MEMORANDUM

SUBJECT: July 28, 2026 HISTORIC PRESERVATION COMMISSION MEETING

STAUNTON HISTORIC PRESERVATION COMMISSION**June 23, 2026****5:30 p.m.****Council Chambers**

HSF Recommendation

6 North Washington Street

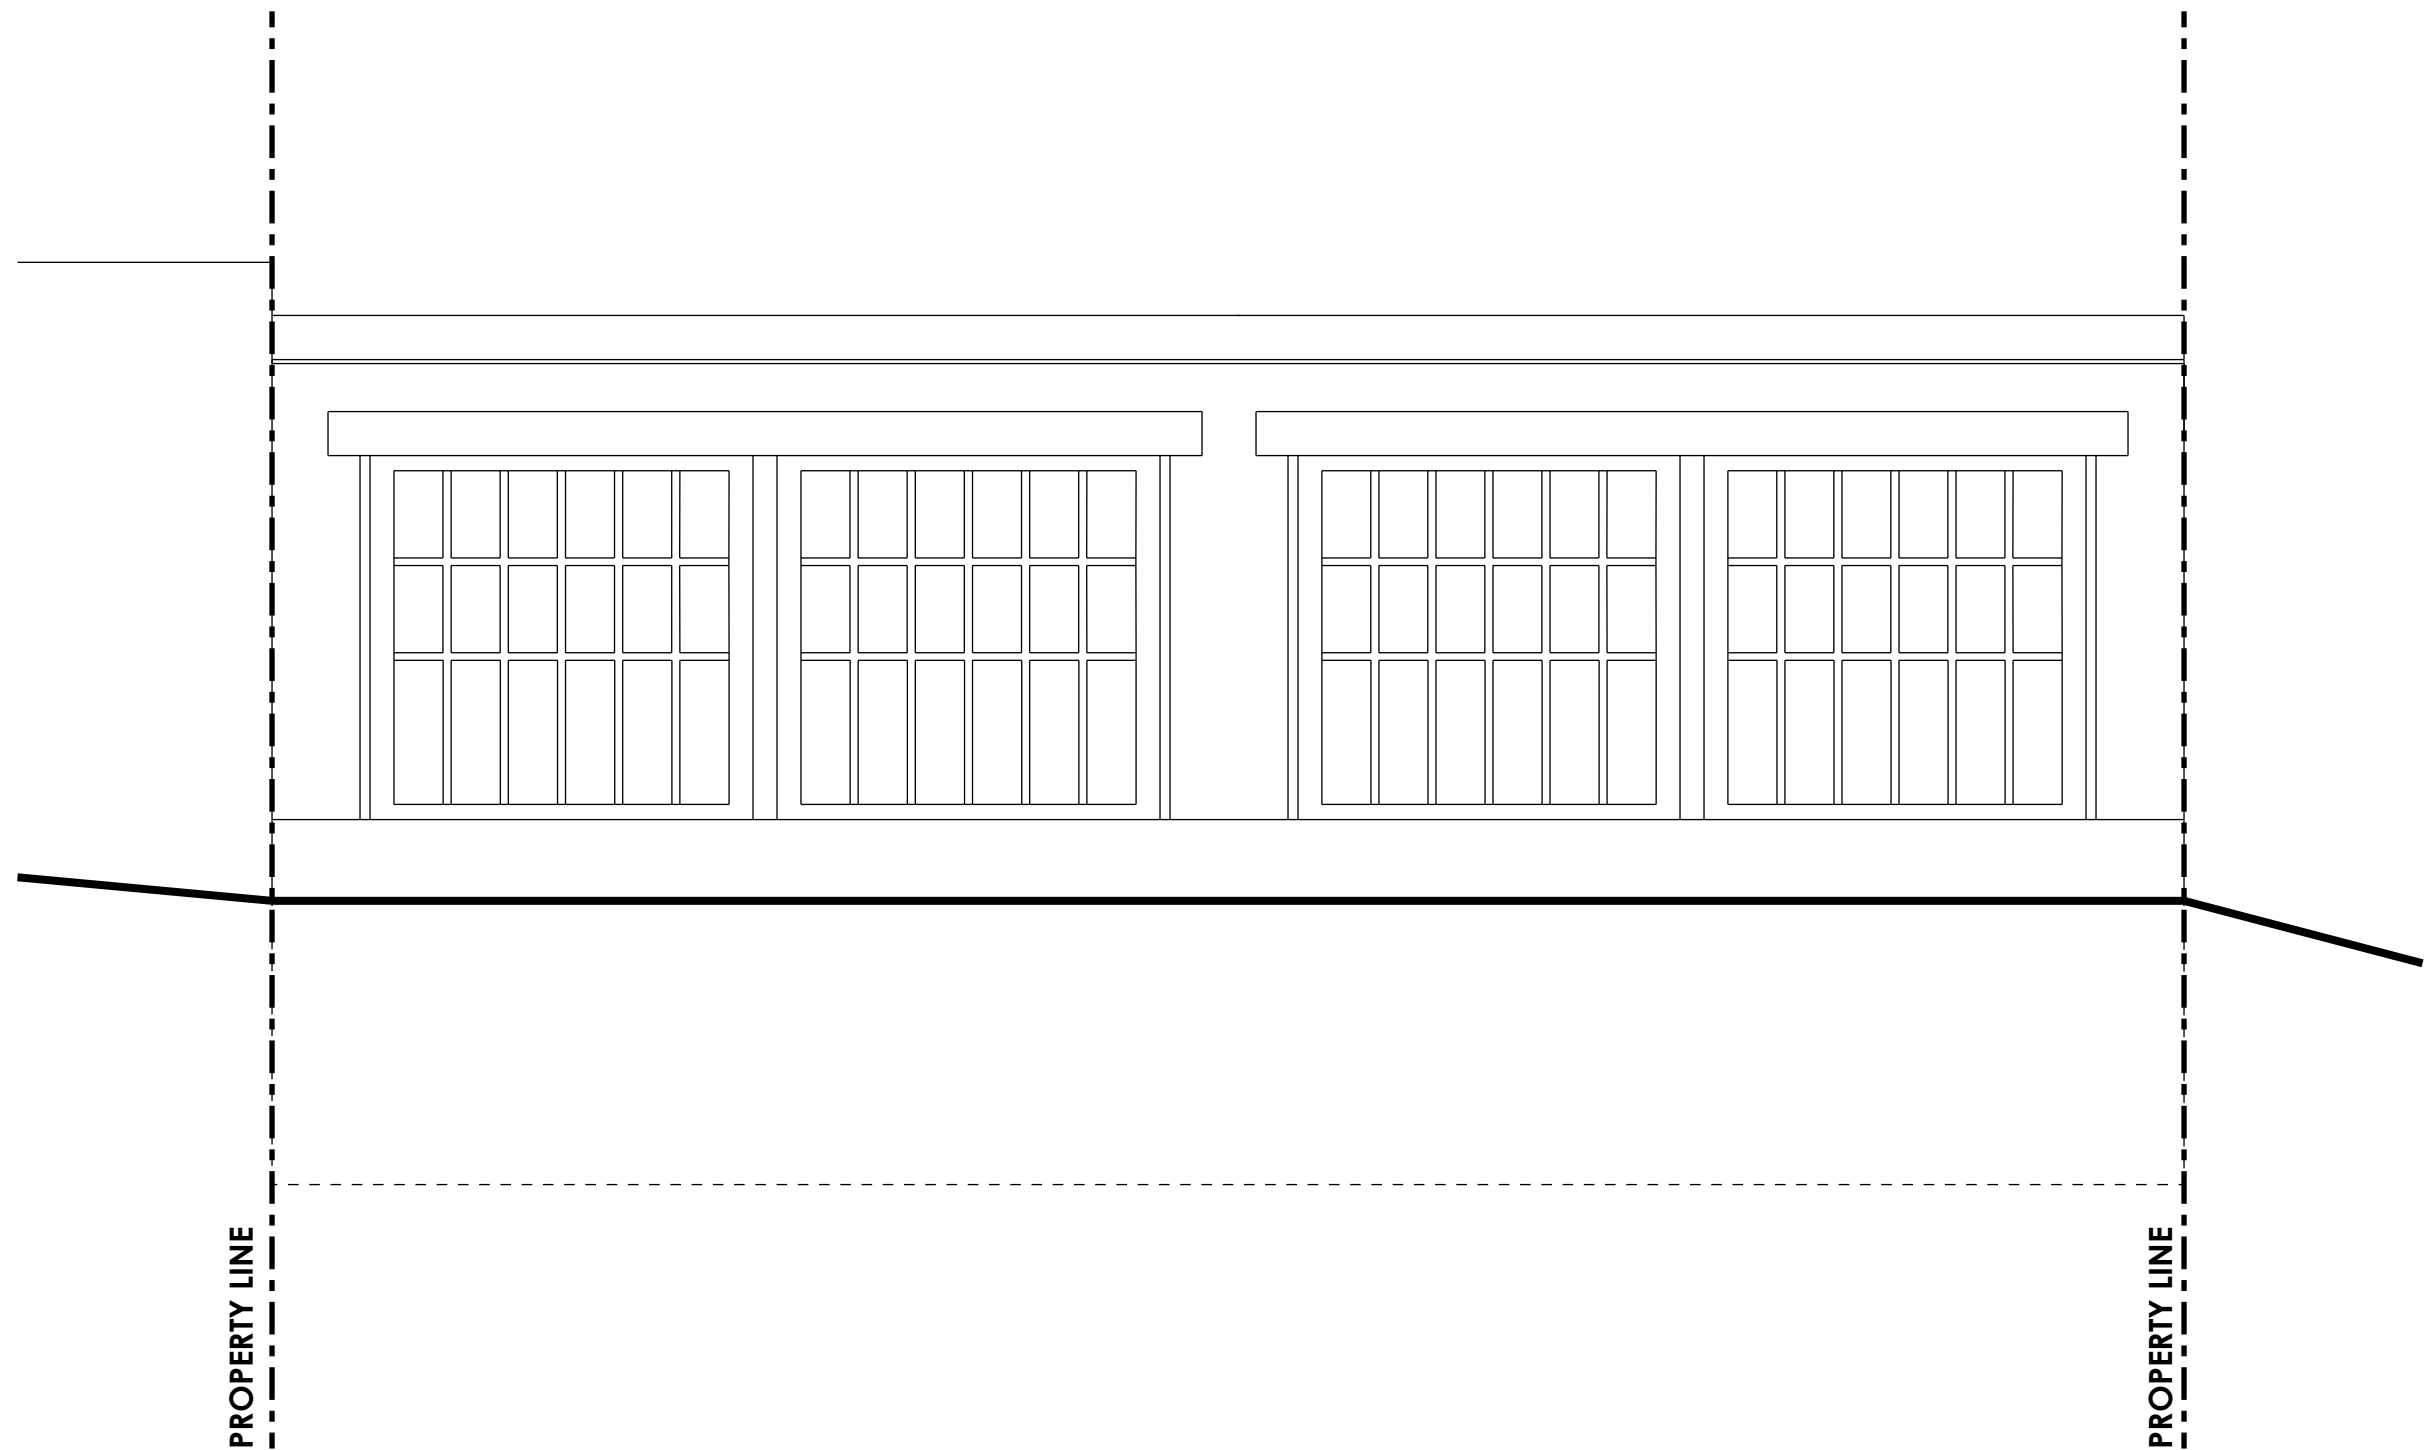
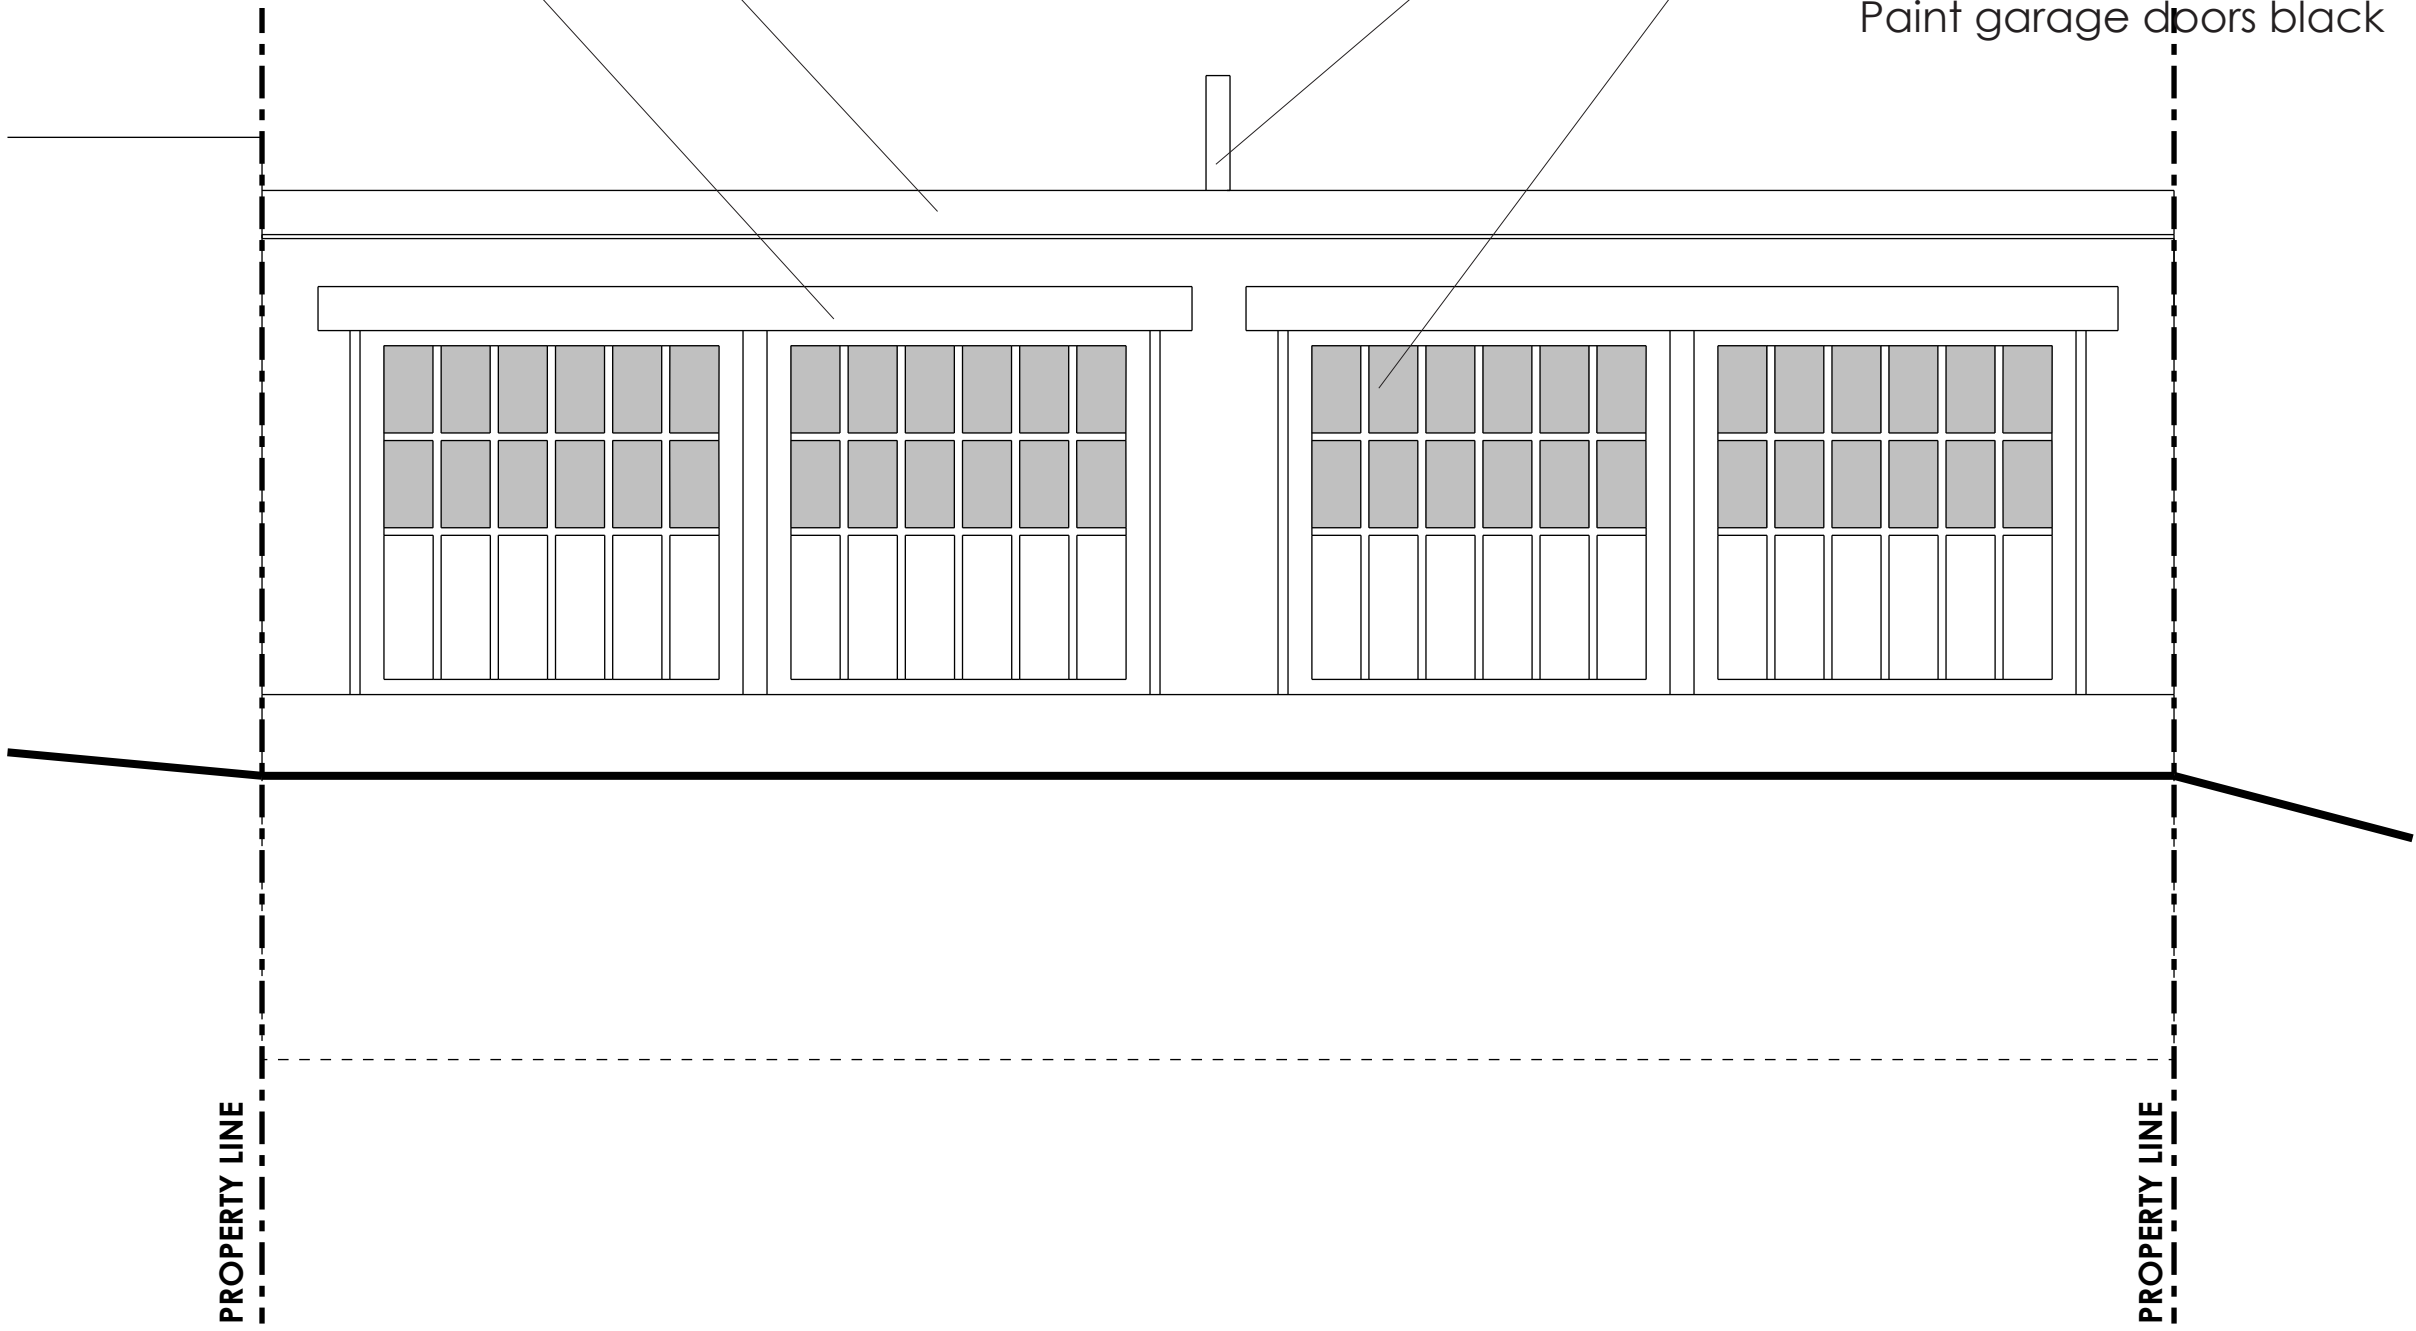
- Add glass panels to the top two rows of the existing garage doors.
- Paint garage doors black
- Add flue pipe for a new interior wood burning stove

The rail and style construction with panels allow a retrofit of the upper panels with glass lights, reflecting the character of early 20th Century garage doors. Therefore, the change alters an existing replacement door by adding compatible glass panels.

Paint existing fascia and soffit black

Paint existing garage doors and header black

Add glass panels to the top two rows of the existing garage doors. Paint garage doors black
